RECEIPT DATE: 3/21/2019 ONSITE SEWAGE DISPOSAL SYSTEM

PROPERTY ADDRESS: 13627 CURTIS VISTA WAY, CLARKSVILLE, MD 21029

Re: Brighton Mill II – Lot 7 OSDS Permit Plan
13627 Curtis Vista Way

We are writing to request a redline revision to the OSDS permit Plan for the above referenced lot. The builder wishes to switch BAT units from the Norweco specified on the plan to the Hoot 600 BNR unit. The pump tank, pump and Low Pressure Dose system will remain the same.

PRE-CONSTRUCTION:

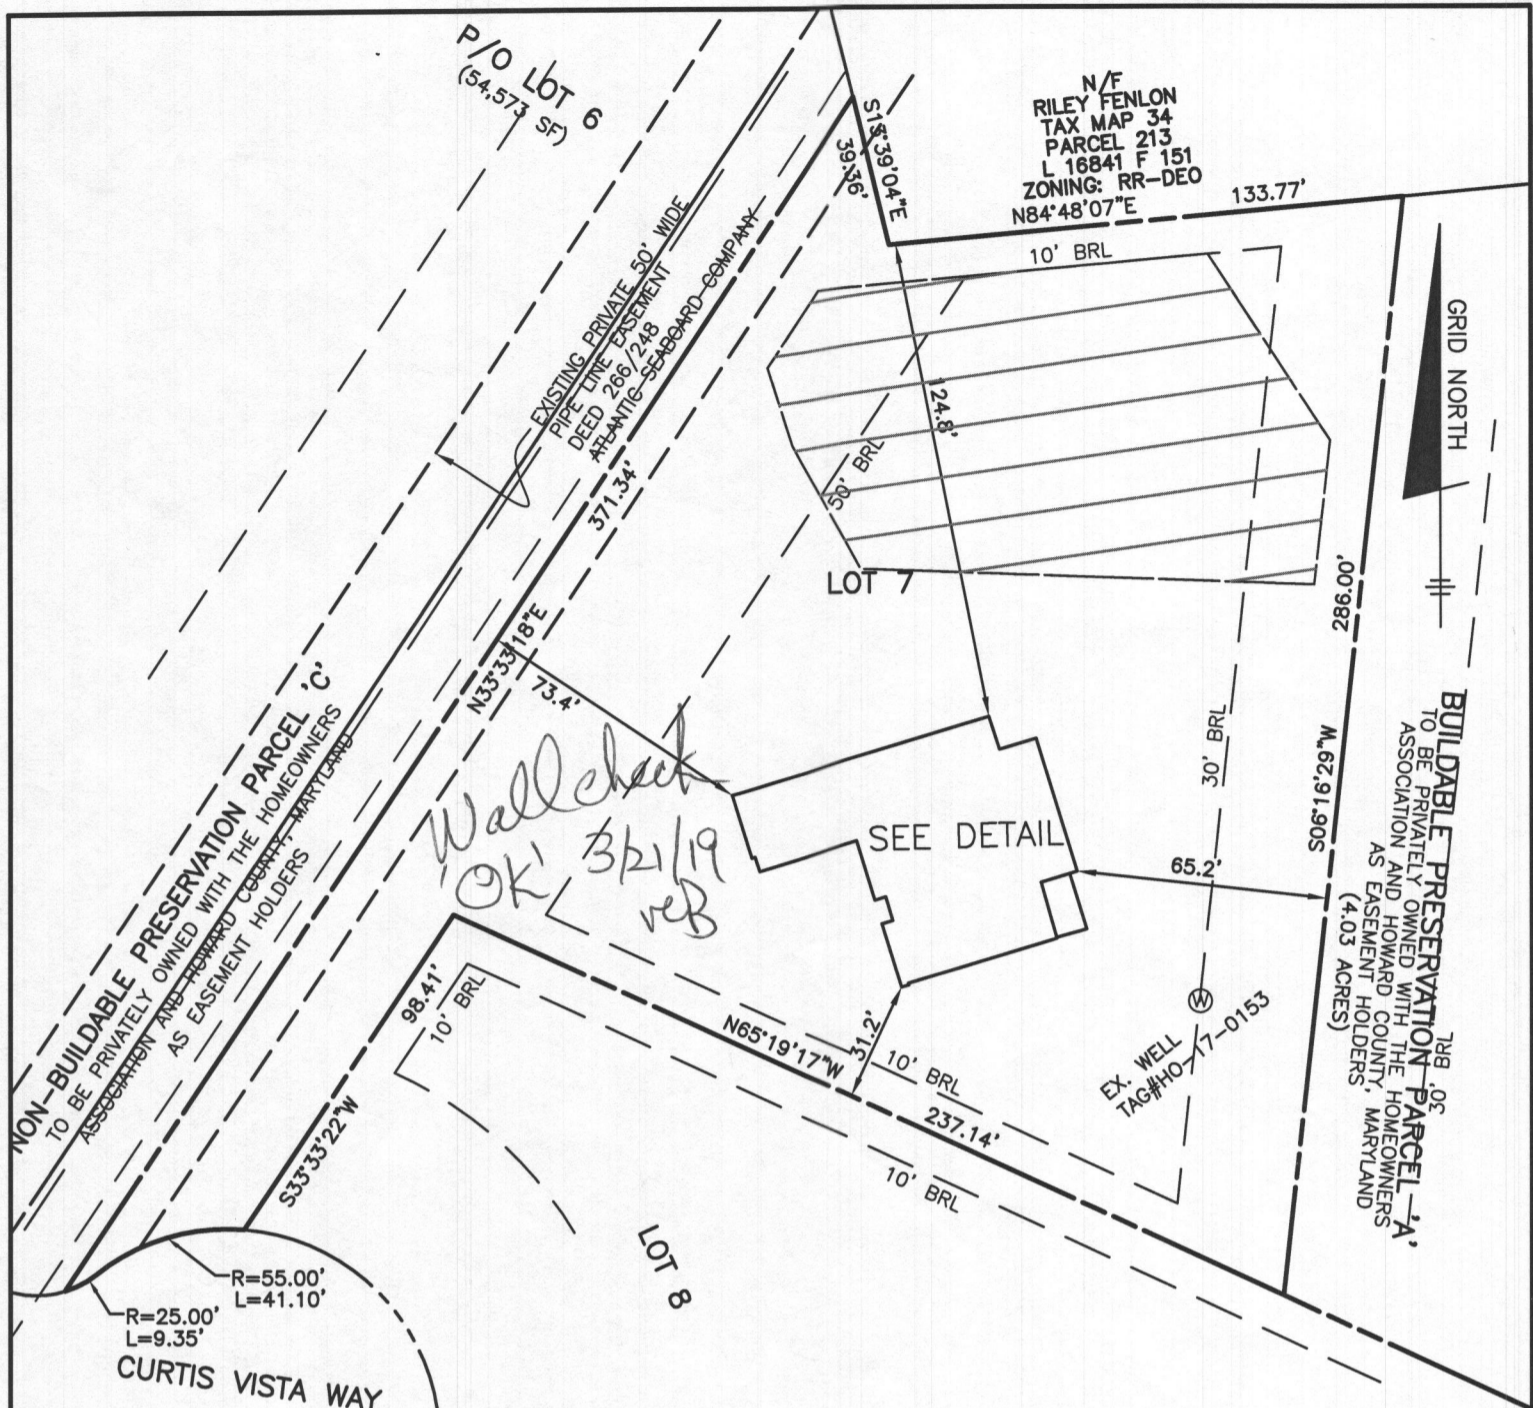
4/15/19 system level out per plan. No issues encountered. OK to proceed per plan (SC)

INSTALLATION: 05/07/2019 TRENCHES CONSTRUCTED TO GRAVEL. LATERALS BEING INSTALLED REINS. HOLE DISTANCE. (C) 5/8/2019 SHC^{NOT} INSTALLED. PARTIAL SEWER LINE AND FORCE MAIN FROM LPD MANIFOLD INSTALLED TOWARD TANK LOCATION. (C) 5/14/2019 TANKS SET. INST VIA PHOTO (C) 5/20/2019 SHC INSTALLED REINS P/A (C) 6/18/2019 HOOT ~~LEFT~~ RIGHT BREAKER CIRCUIT ~~24~~ "SEPTIC" ON LEFT BREAKER CIRCUIT ~~24~~ DHP AT UPPER TRENCH MEETS LATERAL. LOWER TRENCH OVERFLOWS (C)

Hoot 600 BNR

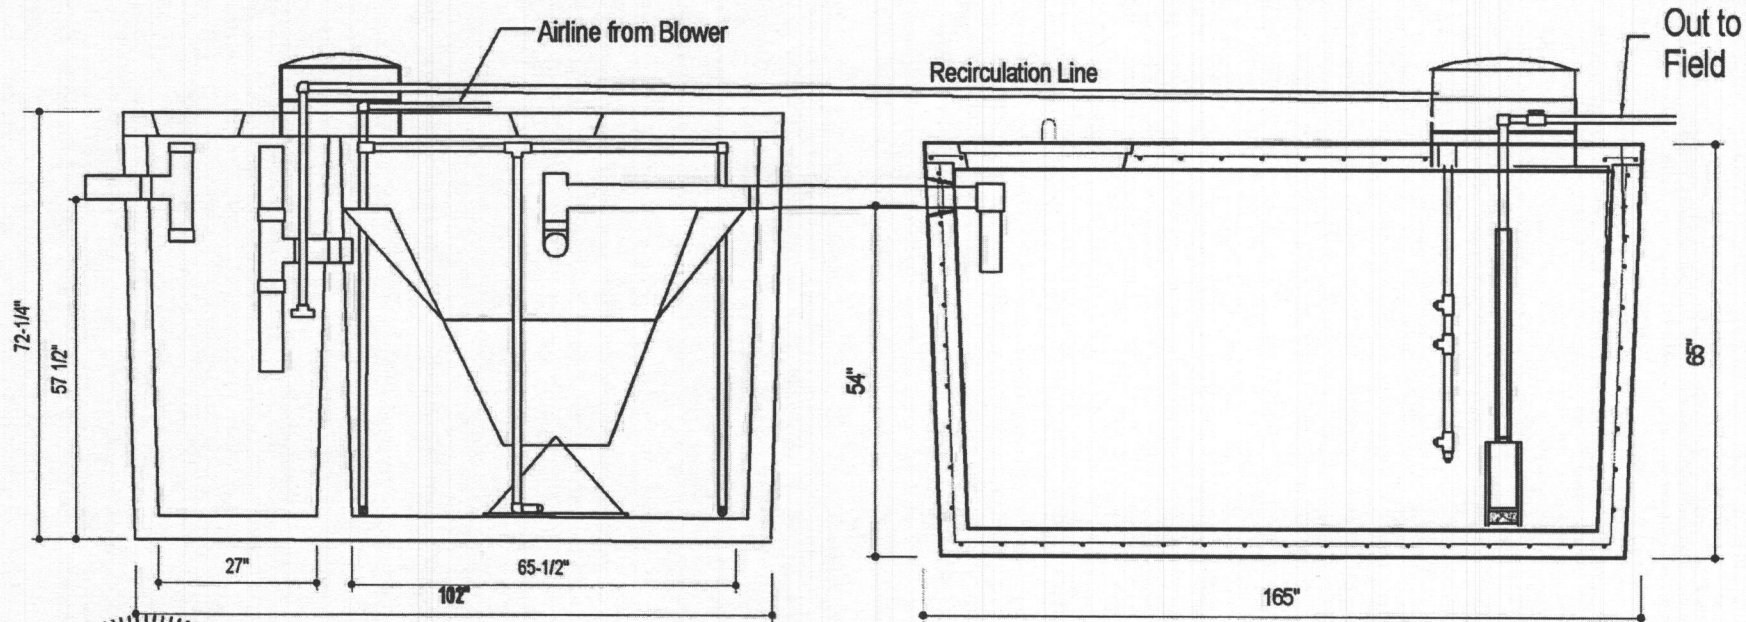
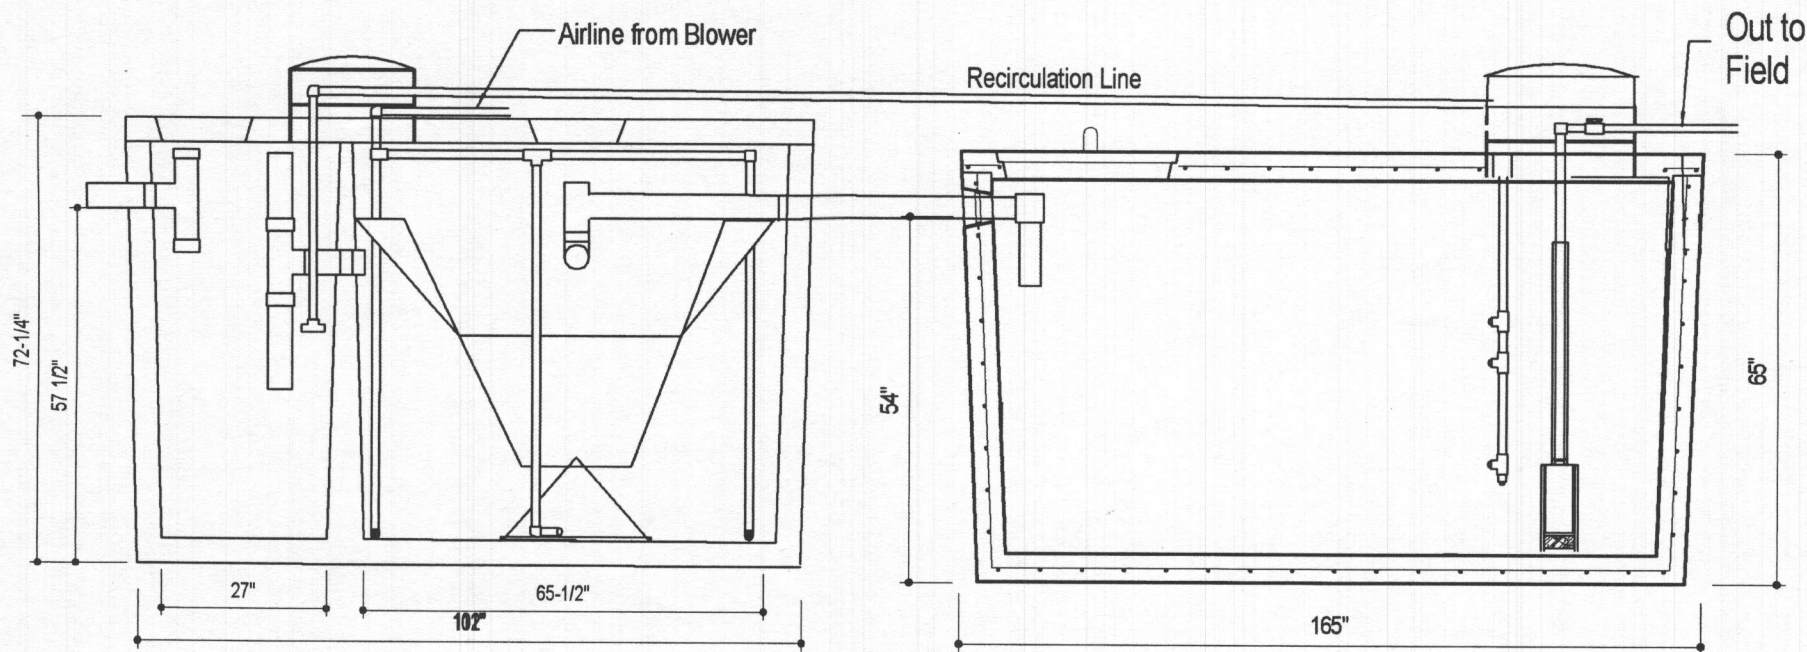
Please add a note on the approved permit plan that states "standard hoot pump will be used and the hoot pump will transition to a 4" gravity line just outside the BAT tank and before the pump tank.

I wanted to follow-up with you on the BAT-LPD Design plan for *13627 Curtis Vista Way*. The current plan shows a Norweco and Pump tank. You are requesting a switch from a Norweco to a Hoot tank 600. Does the switch also include eliminating the pump tank? If so, I think the plan will need to be revised and submitted for review.

Hank,
The Standard Hoot is one -3 compartment tank, trash, aeration and Pump chamber. When a larger pump chamber is needed we call "half" a hoot the first 2 chambers then substitute the attached 750 for a DETACHED larger (2000) gal pump chamber.

Good morning. I am reviewing a septic plan where the owner wants to switch from a Norweco Unit to a Hoot 600 BNR unit, but they want to keep the 2000 gallon pump tank in place. Do you see a problem with this?

Hank, I approve the use of the Hoot BNR 600 in this configuration with a pump tank and pump as specified on the BAT Site Plan for Lot 7. The contractor should hold the elevation of the pump tank and adjust the BAT tank as needed. John
